PLANNING COMMISSION STAFF REPORT

March 21, 2024

AGENDA ITEM: Planning File No. **MAJ-23-0007**, a final review of the Major Site Plan application for a proposed 54 unit multifamily, deed-restricted residential development.

LOCATION: 602 Galena Street / Lots 13 through 21, Block 3, Frisco Townsite

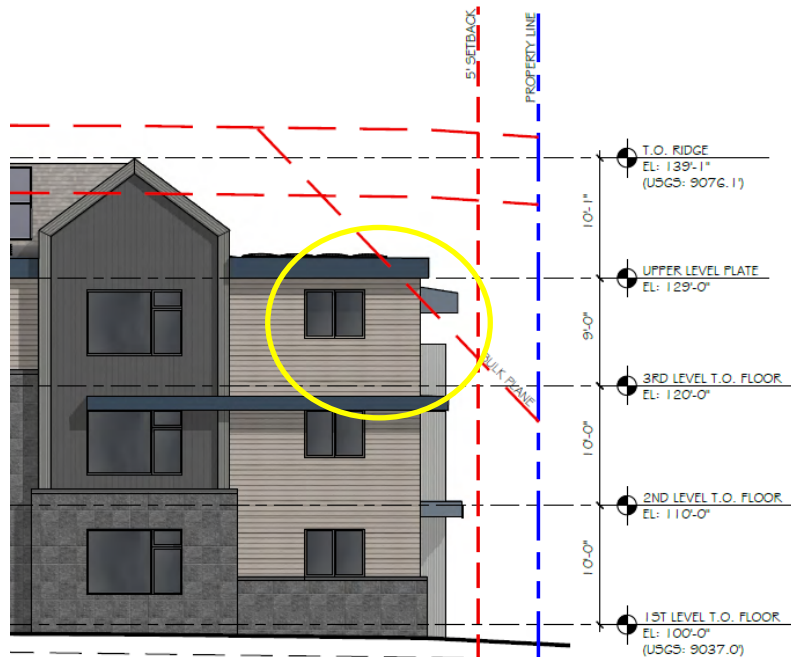
Maximum Lot Coverage: Maximum lot coverage in the CC District for any use other than one (1) or two (2) residential units is 100%. The application materials show 82.7% of lot coverage, meeting the requirements.

Setbacks: The minimum required setbacks in the Central Core, for properties located between Galena Street and Galena Street Alley, and the proposed setbacks for this application are as follows:

While the development is exempt from stepback requirements along alleyways, the building is still required to have a 10-foot stepback along the façade that faces 6th Avenue Alley. The code states that stepbacks shall be taken from the third and above floors of street-facing wall facades, as taken from the floor below. The application materials do not meet this requirement. Staff has spoken to the applicant about making modifications to meet the stepback requirement on the western building façade. Staff recommends the Planning Commission add a condition of approval stating that the applicant shall be required to meet the 10-foot stepback requirement on the western building façade prior to building permit submittal.

6. *Prior to building permit submittal, the applicant shall make modifications to meet the setback requirement on the western building façade.*

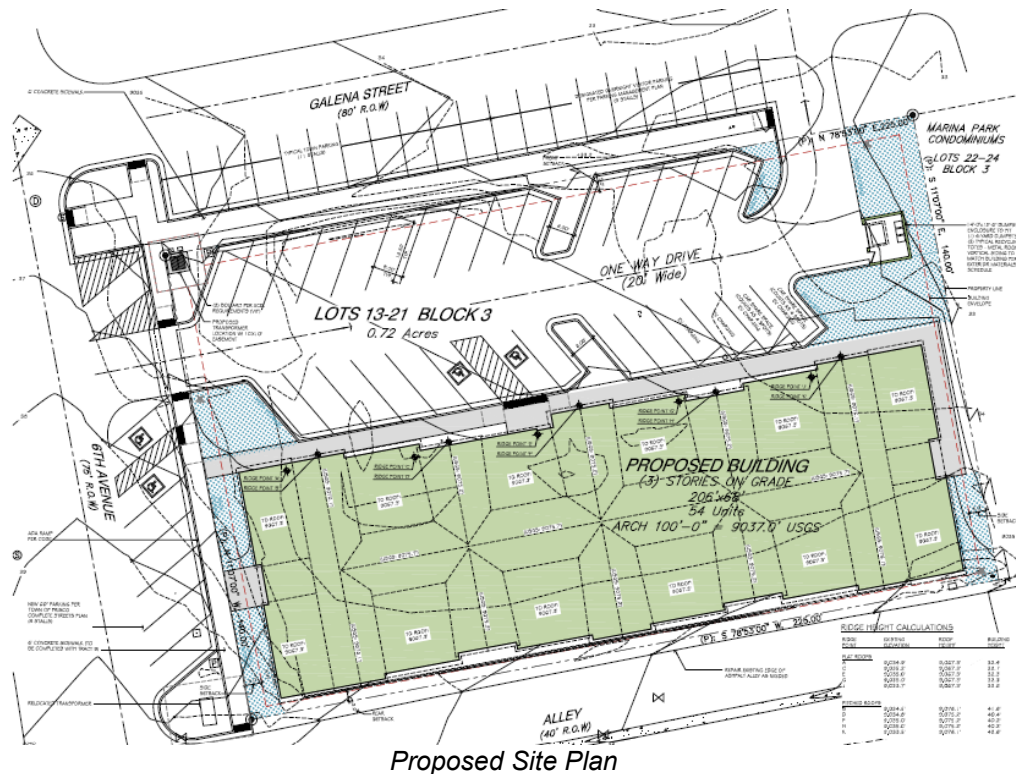
Maximum Building Height: Maximum height in the CC District is 40 feet for pitched roofs. However, with the Affordable Housing Development Incentive Program, there is a 10% increase in maximum building height. Therefore, the proposed building is allowed to have a height of 44 feet. All roof height measurements are taken from the existing elevation on site and the highest roof height proposed is 39.1 feet, meeting the requirements.

An Improvement Location Certificate (ILC) will be required during construction to ensure the structure meets the height requirements.

Bulk Standards (§180-6.23):

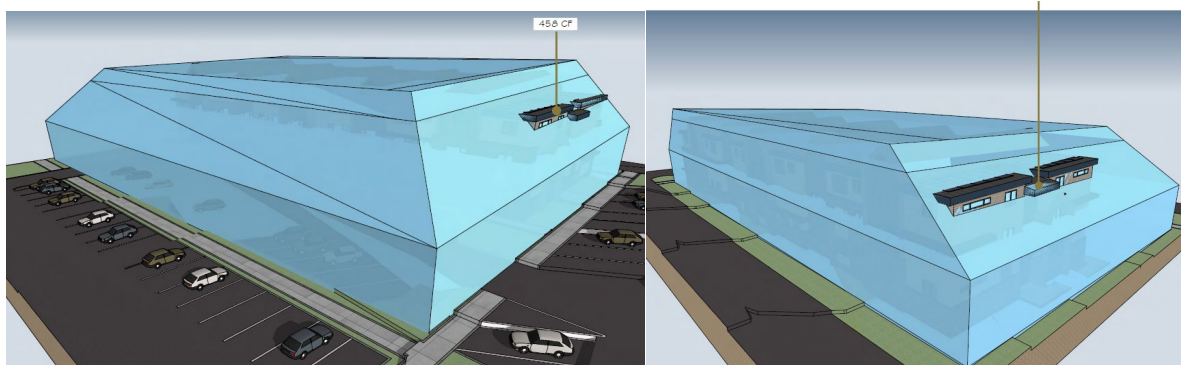
Table 6-K of the UDC outlines bulk plane requirements. §180-6.23.3 of the UDC states that building forms may deviate from this standard and project beyond the bulk plane if they do not exceed maximum building height and provide substantial architectural relief, with Planning Commission approval. The Affordable Housing Development incentives allow bulk plane encroachments up to the ratio of 500 cubic feet per 10,000 square feet of lot area. The application materials show 1,444 cubic feet of bulk plane encroachments, where 1,574 cubic feet is allowed.

If the Planning Commission finds that the proposed bulk plane encroachments provide substantial architectural relief and advance the intent of Section 180-6.23, then the application meets this standard.
